Access Compliance Report

Public Rights-of-Way

Intersection ID: 16436	Main Street: HAMPTON_AV	Cross Street: PORTLAND_AV	Location: SE
ADA ID: 12E5758D70CE	Ramp Type: PerpDiag	Initial Pass/Fail: Pass	Overall Compliance: No
		Severity Score: 27.5

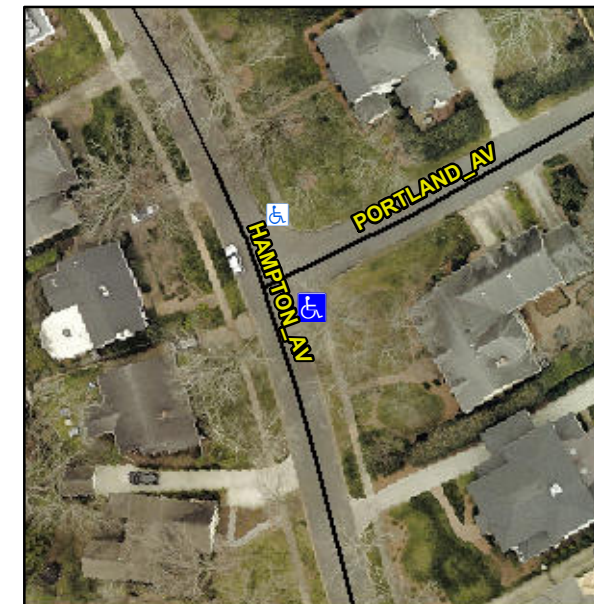
Not Found, R304.2.1, R304.2.2-Perp, R304.3.2-Para, R304.5.3, R305, R302.7.2

Compliance	Description	Data	Compliance	Description	Data
N/A	Ramp Length (in)	46.0	Yes	Ramp Slope (%)	6.7
Yes	Ramp Width (in)	49.0	Yes	Ramp XSlope (%)	0.8
N/A	Flare Type LT	Sloped	N/A	Flare Type RT	N/A
N/A	Flare Slope LT (%)	6.3	N/A	Flare Slope RT (%)	2.1
N/A	Flare Traversable LT?	No	N/A	Flare Traversable RT?	No
No	Landing Length (in)	N/A	No	DWS Provided?	No
No	Landing Width (in)	N/A	N/A	DWS Contrast?	No
No	Landing Slope (%)	N/A	N/A	DWS Length (in)	N/A
No	Landing X Slope (%)	N/A	N/A	DWS Full Width?	No
N/A	Landing Curb? (Y/N)	No	N/A	DWS Offset (in)	N/A
N/A	Shared Landing?	N/A			
Yes	Gutter Ponding?	No	Yes	Gutter Slope (%)	3.9
No	Gutter Lip Ht (in)	0.5	No	Gutter X Slope (%)	2.1
N/A	Painted X Walk1?	No	N/A	Painted X Walk2?	No
	X Walk 1 Direction	To N		X Walk 2 Direction	To W
N/A	X Walk 1 Width (in)	N/A	N/A	X Walk 2 Width (in)	N/A
	X Walk 1 Slope (%)	4.2		X Walk 2 Slope (%)	2.6
	X Walk 1 X Slope (%)	0.4		X Walk 2 X Slope (%)	3.0

Remove & Replace Curb Ramp With Two New Directional Ramps or Equivalent. Remove & Replace Gutter.
